Proposed Revisions to a Standard Plans Index

Originator:	Turley, Joshua	Index Number:	649-020
Date:	4/17/2024	Sheet Number(s):	3 and 4
E-mail:	Joshua.Turley@dot.state.fl.us	Index Title:	STEEL CCTV POLE

STEEL CCTV POLE

INDEX
649-020

SECTION A-A

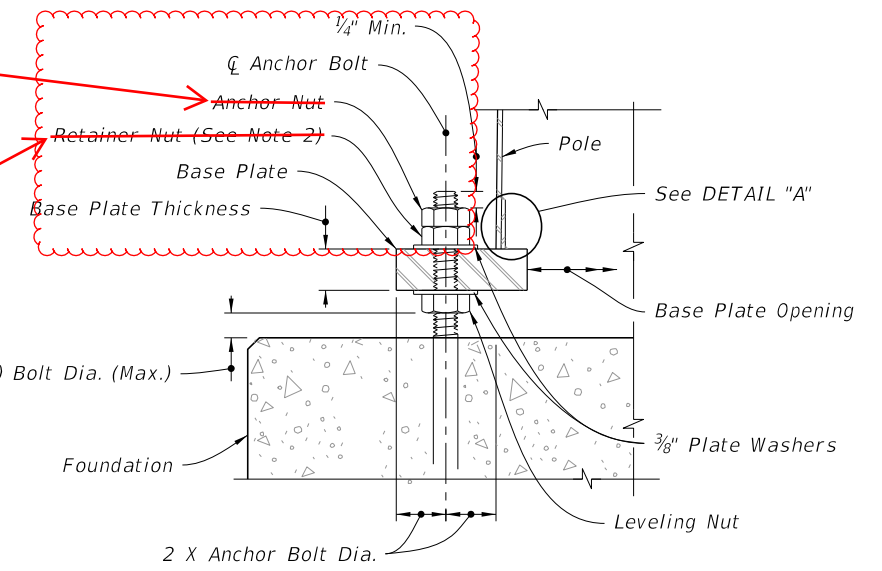
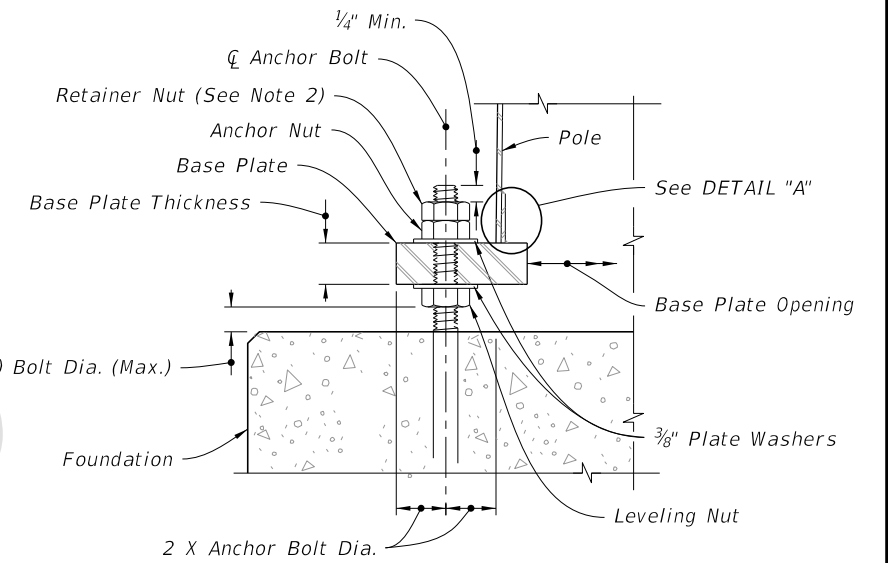
Sheet 3: Section A-A -- Corrected the label order of the anchor bolt nuts; SECTION B-B -- Modified wall thickness from text to symbol. DETAIL A -- Removed weld hatches and modified weld symbol. Removed "Pole Wall Thickness + 7/16" dimension from Joint Weld Detail. Added welding callout to Joint Weld Detail.
 Sheet 4: FRAME DETAIL -- Modified weld detailing and modified title; SECTION C-C -- Modified weld detailing; Updated callouts and added dimensions to Rod and Eye Bolt Options.

REVISED: Retainer Nut (See Note 2)

REVISED: Anchor Nut

Sheet 3: Anchor nut labels were adjusted to correspond correctly with upcoming associated Spec change being drafted for Section 649; We corrected weld detailing for clarity and brevity.
 Sheet 4: We corrected weld detailing to conform with accepted convention.

DETAIL "A"

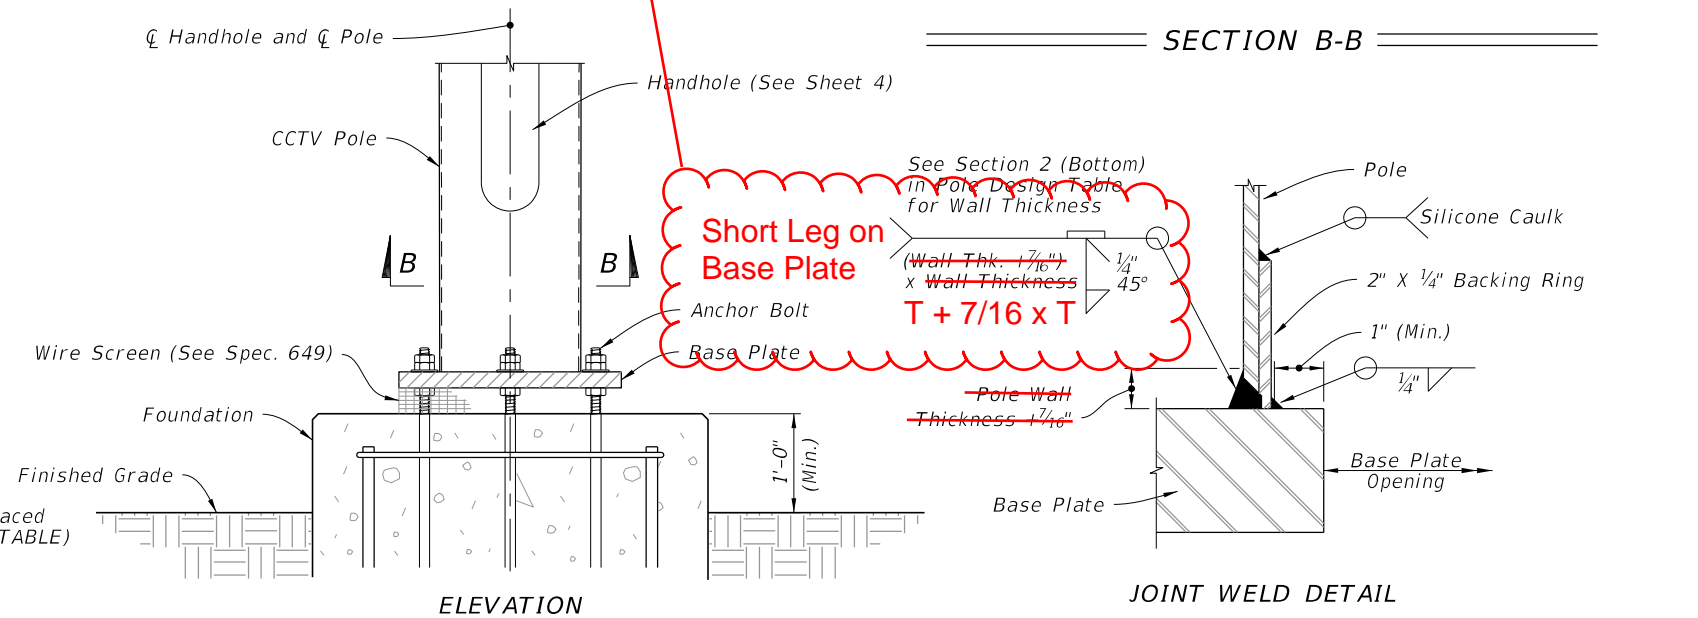
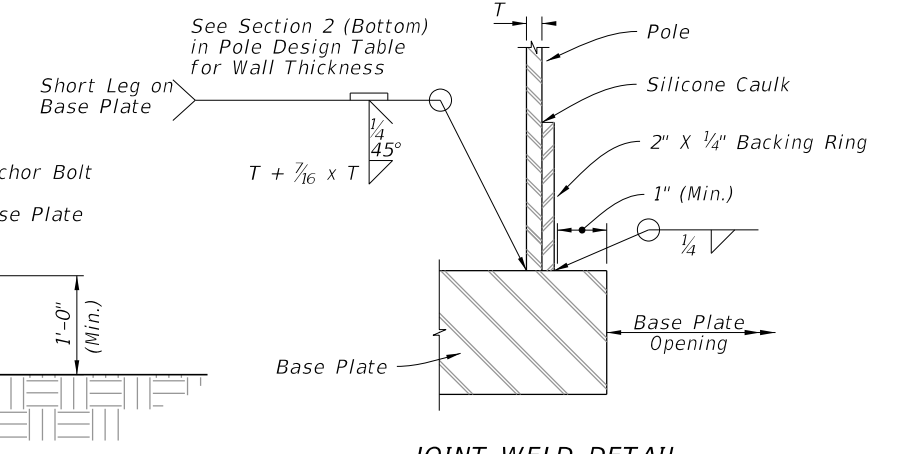
UPDATED Callouts

SECTION C-C

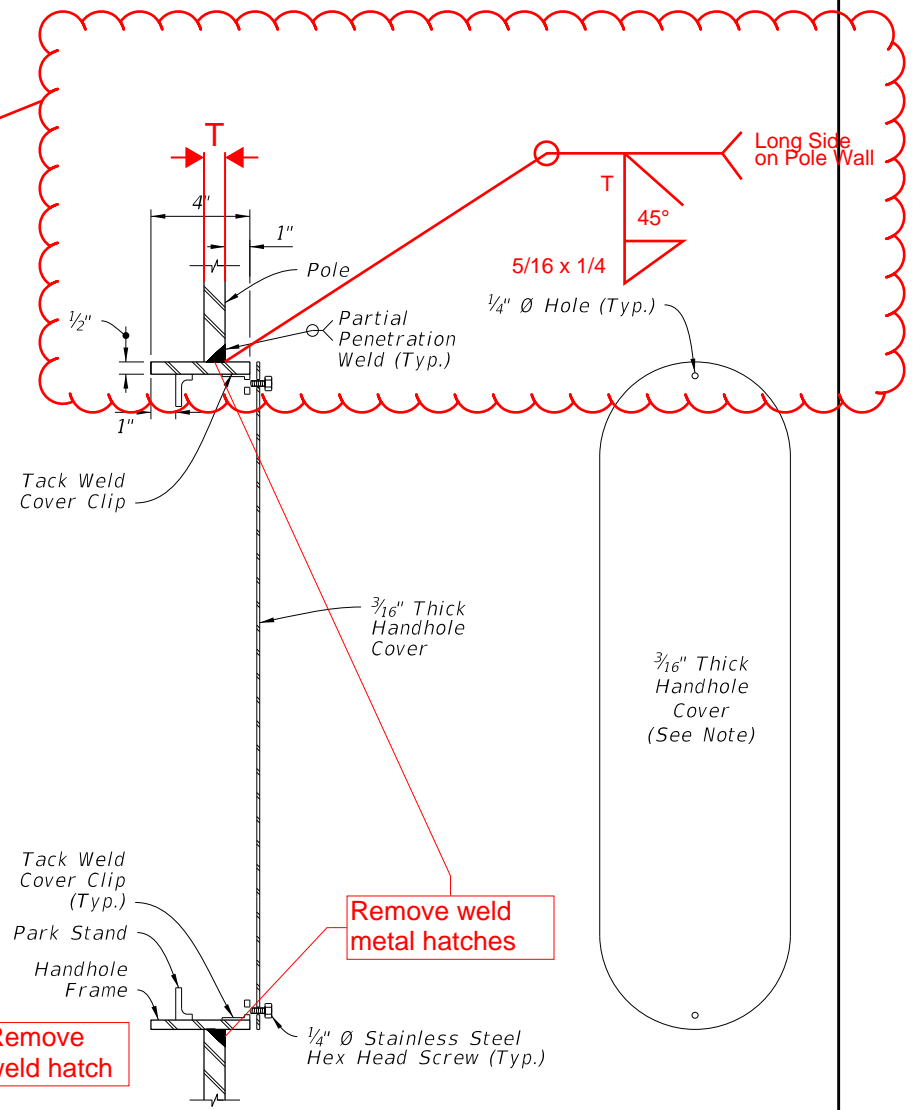
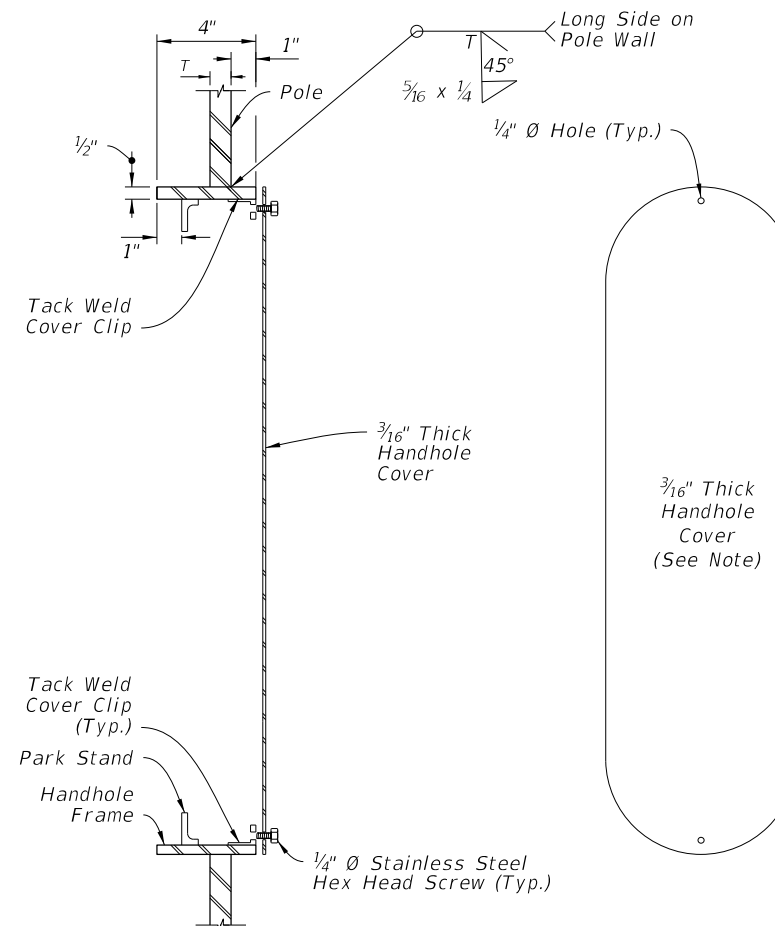
UPDATED Weld Callout and ADDED Dimension
